Labor Saver™: 2016-2002 GM 1500 Truck & SUV Front Lower Ball Joint (Cast Iron Control Arm)

Brand	Supreme	Product	Ball Joint	Date	December 2022
Part Number(s)		MK6541

Figure 1. Mevotech Supreme front lower ball joint MK6541 can be secured to the control arm easily via the included circlip (left) vs OEM stake/crimp method (right)

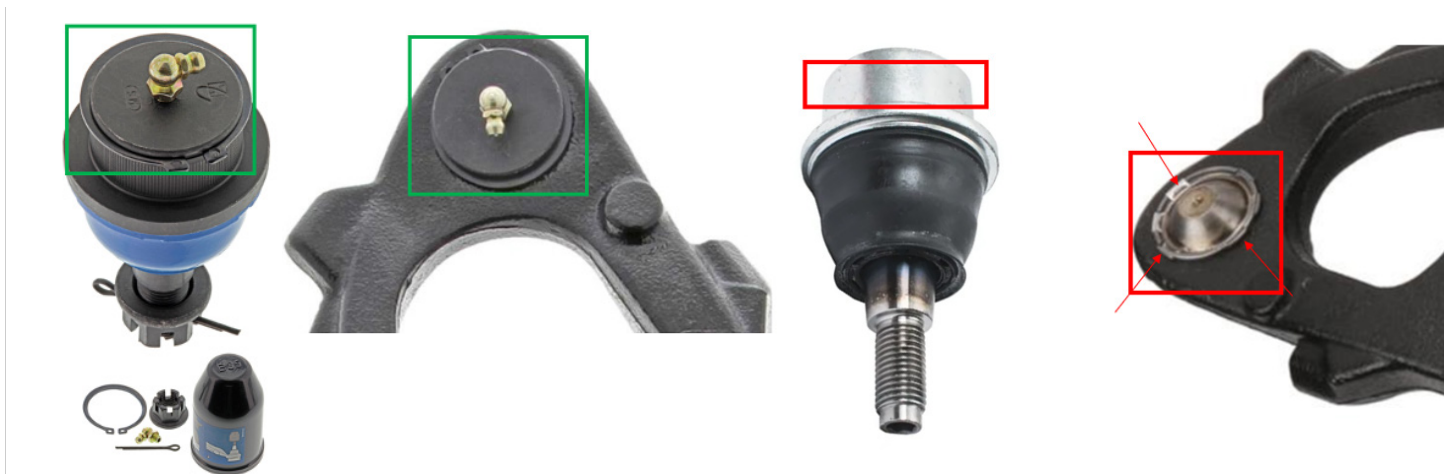
The OEM (PN: 19209396 and various other OE-style) front lower ball joints for the applications associated with the below listed part number require to be staked/crimped after press-in.

Mevotech Supreme front lower ball joint MK6541 is engineered to utilize a circlip as the supplementary retention method. This reduces installation time for the Professional Technician and is a frustration-free alternative to the staking/crimping method. Additionally, the potential of damage to the control arm body is limited when securing the ball joint after press-in. **See Figure 1.**
